STAGE 1 ROAD SAFETY AUDIT

Lackareagh Wind Farm, Co. Clare

Stage 1 Road Safety Audit

EDF Renewables Ireland Ltd.

Figure 2.2 – Field Boundaries Impacting Upon the Right-Hand Sightline

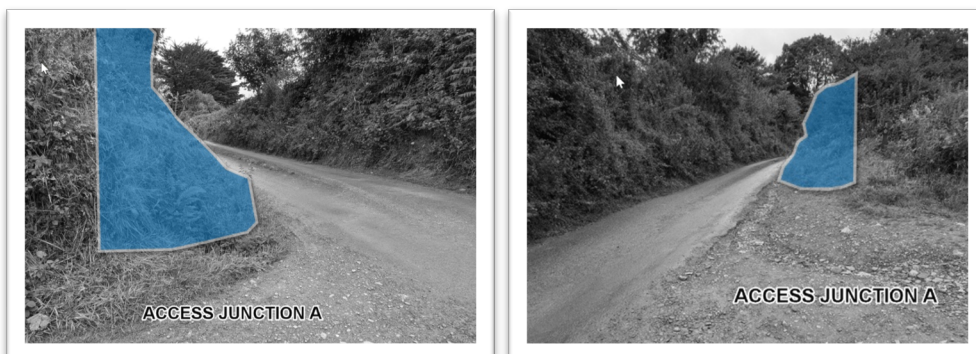
2.2 Problem: Sightlines Partially Obscured by Field Boundary

Location: Access Junction A | Field Boundaries Along Local Road L7080

Junction sightlines appear to be partially obscured by the existing field boundaries, which includes ditch foliage and some trees. This could lead to side impact type collisions within the access junction's conflict zone.

The field boundaries should be modified to ensure that appropriate sightlines are provided at the access junction.

2.2	Yes	Yes	As shown in Figure 15-8 of Chapter 15 of the EIAR, the L-7080 and the existing junction will be improved with visibility splays appropriate for traffic speeds during construction and the operational phase provided. It is noted traffic management measures, including signage and a "flagman" will be in place at all times during the construction phase.	Designer comment noted and accepted.
